**Office Action Summary**

10/798,182

### DETAILED ACTION

This office action is in response to the amendment and remarks filed 5/26/05. Since the examiner has applied new grounds of rejection, this office action is being made non-final to afford the applicant the opportunity to respond to the new grounds of rejection.

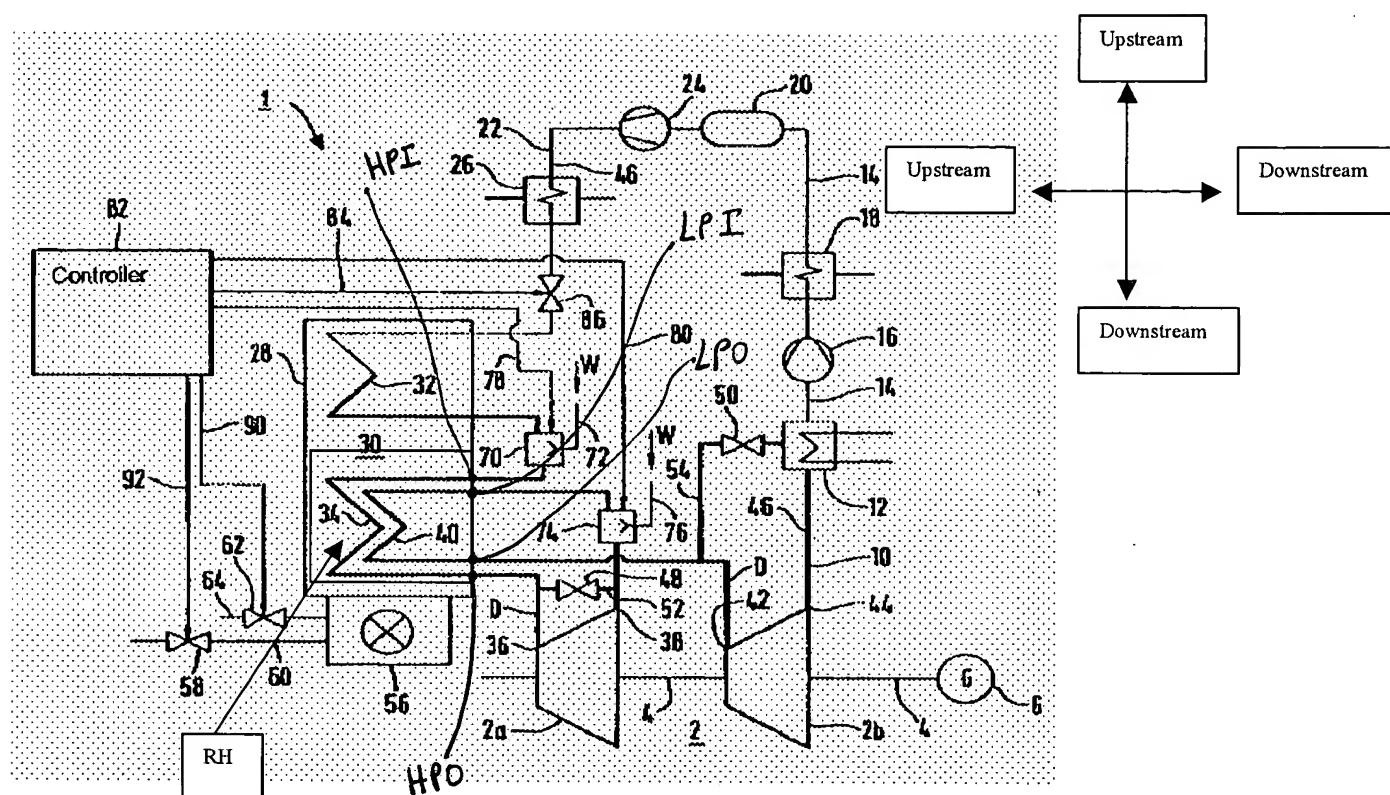
With respect to claim 1, **Kallina** teaches a power generation system comprising: a high temperature high pressure source 32 of working fluid; a reheat heat exchanger RH having a high pressure inlet HPI downstream from said high temperature high pressure source of working fluid, a high pressure outlet HPO, a low pressure inlet LPI, a low pressure outlet LPO, a high pressure path 34 between said high pressure inlet and said high pressure outlet and a low pressure path 40 between said low pressure inlet and said low pressure outlet, said high pressure path located in heat transfer relationship with said low pressure path; an expander 2a having an inlet downstream from said high pressure outlet and a discharge 38, said expander 2a adapted to expand the working fluid therein from a higher pressure to a lower pressure; and said discharge 38 of said expander upstream from said low pressure inlet of said reheat heat exchanger. See **Figure 1** of Kallina above.

With respect to claim 2, **Kallina** teaches that a temperature of the working fluid at said high pressure inlet HPI of said reheat heat exchanger is greater than a maximum inlet temperature for said expander. The HPO is connected to the inlet 36 of expander 2a. The temperature at the HPO is lower than the temperature at the HPI since heat exchange has occurred between paths 34 and 40. Thus the temperature at the inlet to expander 2a should be lower than the HPI temperature. See **Figure 1** of Kallina above.

With respect to claim 3, **Kallina** teaches that a temperature of the working fluid at said high pressure outlet HPO of said reheat heat exchanger is less than or equal to a maximum inlet temperature for said first expander (inherent otherwise if the temperature excess a maximum inlet temperature of the expander, the expander may be damaged by the excessive heat). See **Figure 1** of Kallina above.

With respect to claim 4, **Kallina** teaches that a second expander 2b is located downstream from said low pressure outlet of said reheat heat exchanger. See **Figure 1** of Kallina above.

With respect to claim 19, **Kallina** teaches a power generation system having a high temperature high pressure source 32 of a working fluid, a first working fluid expander 2a, a second working fluid expander 2b downstream from the first working fluid expander, a reheat heat exchanger RH having a high pressure inlet HPI, a high pressure outlet HPO, a low pressure inlet LPI, a low pressure outlet LPO, a high pressure path 34 between the high pressure inlet and the high pressure outlet, and a low pressure path 40 between the low pressure inlet and the low pressure outlet, the high pressure path located in heat transfer relationship with the low pressure path; and the high pressure inlet of the reheat exchanger RH located downstream from the source

of high temperature high pressure working fluid 32, the high pressure outlet located upstream from the first working fluid expander 2a, said low pressure inlet located downstream from a discharge 38 of the first working fluid expander, and the low pressure outlet located upstream from the second working fluid expander 2b. See **Figure 1** of Kallina above.

With respect to claim 28, **Kallina** teaches a power generation system comprising: a high temperature high pressure source 32 of working fluid; a reheat heat exchanger RH having a high pressure inlet HPI downstream from said high temperature high pressure source of working fluid, a high pressure outlet HPO, a low pressure inlet LPI, a low pressure outlet LPO, a high pressure path 34 between said high pressure inlet and said high pressure outlet and a low pressure path 40 between said low pressure inlet and said low pressure outlet, said high pressure path located in heat transfer relationship with said low pressure path; an expander 2a having an inlet downstream from said high pressure outlet and a discharge 38, said expander 2a adapted to expand the working fluid therein from a higher pressure to a lower pressure; and said discharge 38 of said expander upstream from said low pressure inlet of said reheat heat exchanger. **Kallina** is silent about the details of the internal structure or the type of reheat exchanger being used. However, **The Engineering Handbook (TEHB)** teaches a very efficient and commonly used reheat heat exchanger for power generation, said reheat exchanger comprising: a casing; a pair of tube sheets interfacing with said casing; a plurality of tubes extending between said tube sheets, a 1<sup>st</sup> inlet located adjacent at least one of said tube sheets; a 1<sup>st</sup> outlet located adjacent at least one of said tube sheets and opposite said 1<sup>st</sup> inlet, a 1<sup>st</sup> path extending between said 1<sup>st</sup> inlet and said 1<sup>st</sup> outlet, said 1<sup>st</sup> path defined at least partially by interiors of said tubes; a 2<sup>nd</sup> inlet passing through said casing; a 2<sup>nd</sup> outlet passing through said casing; and a 2<sup>nd</sup> path extending between said 2<sup>nd</sup> inlet and said 2<sup>nd</sup> outlet and in contact with an exterior surface of said tubes. Therefore, it would have been obvious to one of ordinary skill in the art at the time the invention was made to have used TEHB's reheat exchanger as Kallina's reheat exchanger since this type of heat exchanger was readily available and commonly used taught by TEHB due to its efficient heat

With respect to claim 29, **Kallina** teaches that a second expander 2b is located downstream from said low pressure outlet of said reheat heat exchanger. See **Figure 1** of Kallina above.
